UNITED STATES PATENT AND TRADEMARK OFFICE

Office Action Summary

10/561,106

DETAILED ACTION

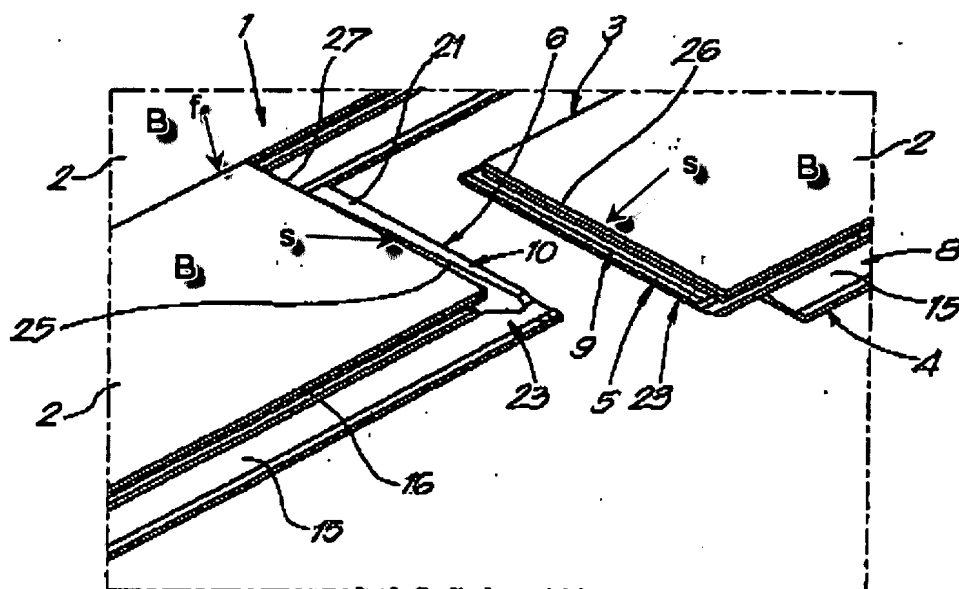
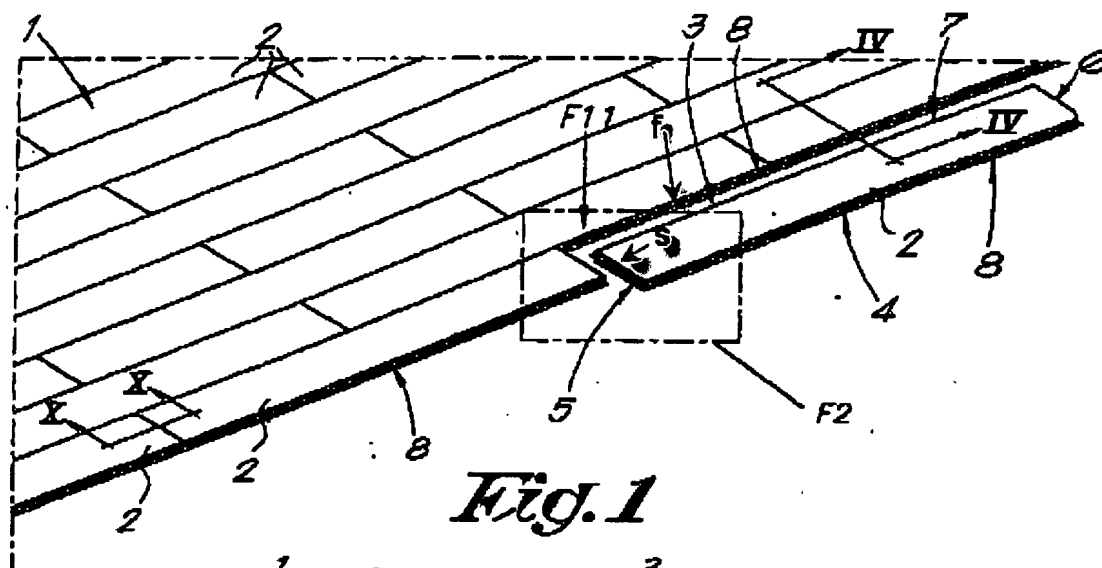
Regarding claim 37, Thiers discloses that there is at least one contact area (c) between two locking elements (9, 10) which area runs in a perpendicular direction relative to the surface (B), (annotated Figure 10).

Regarding claim 38, Thiers discloses that there is at least one contact area (u) between two locking elements (9, 10) formed by undercuts, (annotated Figure 10).

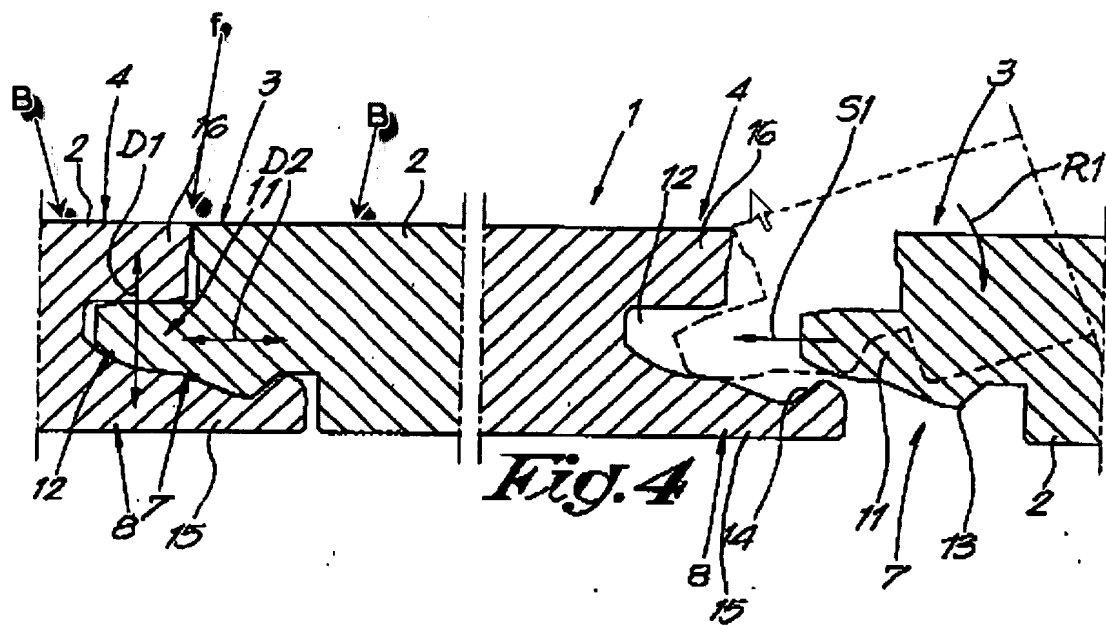
Regarding claim 39, Thiers discloses one board (2) laterally having, as a locking element, at least one groove (18) and another board (2) laterally has at least one tongue (17), (annotated Figure 10).

Fig. 15

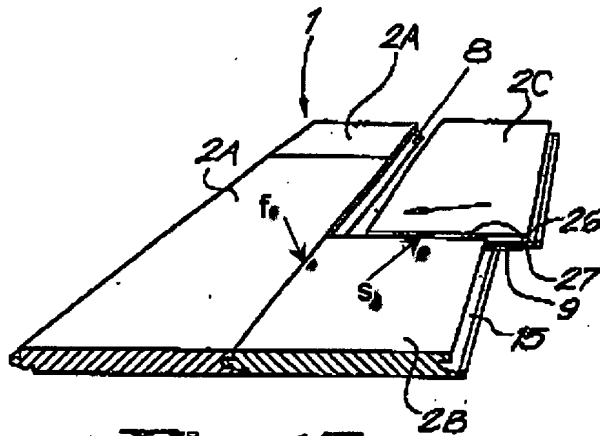
Regarding claim 31, Thiers discloses the locking elements (7-8, 9-10) are such that the boards (2) can be brought into the initial position when, along the common connecting joint (f, s), they are arranged offset relative to one another by more than 50% and less than 100%, (annotated Figures 4, 10, 15).

Regarding claim 51, Thiers discloses the locking elements (7-8, 9-10) are such that the boards (2) can be brought into the initial position when, along the common connecting joint (f, s), they are arranged offset relative to one another by more than 66% and less than 80%, (annotated Figures 4, 10, 15).

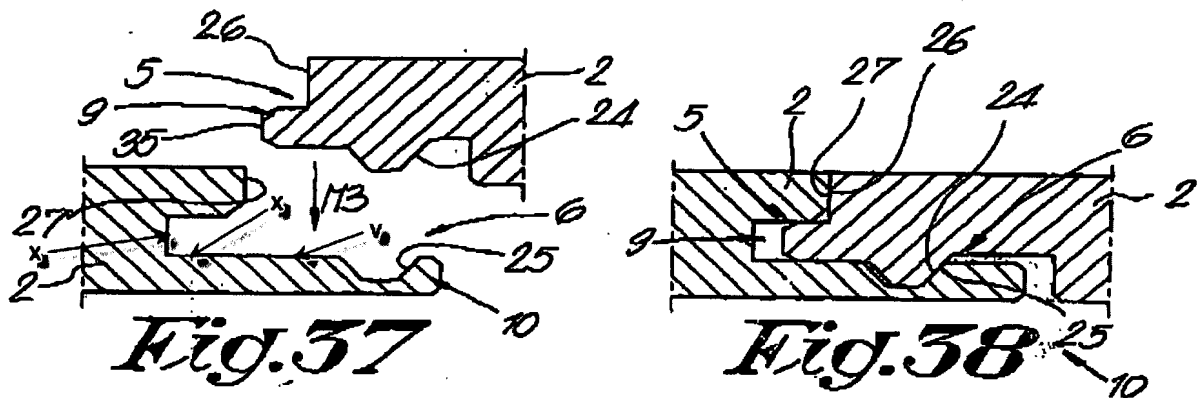
8. Claims 36 and 43 are rejected under 35 U.S.C. 103(a) as being unpatentable over Thiers (WO 2004/048716 A1) in view of Konzelmann (US 2004/0168392). Thiers discloses as discussed in claim 35, but does not disclose at least one lateral wall of a groove that is provided as a locking element runs in an arched, wave-like, serpentine or sawtooth-like manner. However, Konzelmann teaches lateral wall (10) of a groove (7) that is provided as a locking element runs in a serpentine manner, (Figure 1), (Paragraph 62). Therefore, it would have been obvious to a person having ordinary skill in the arts at the time of the applicant's invention to modify the lateral wall of a groove

as taught by Konzelmann in order to facilitate movement of one board towards the other. Konzelmann does not show an arched, wave-like, or sawtooth-like manner. However, Konzelman serpentine manner is considered to be an obvious variation of an arched, wave-like, or sawtooth-like manner.
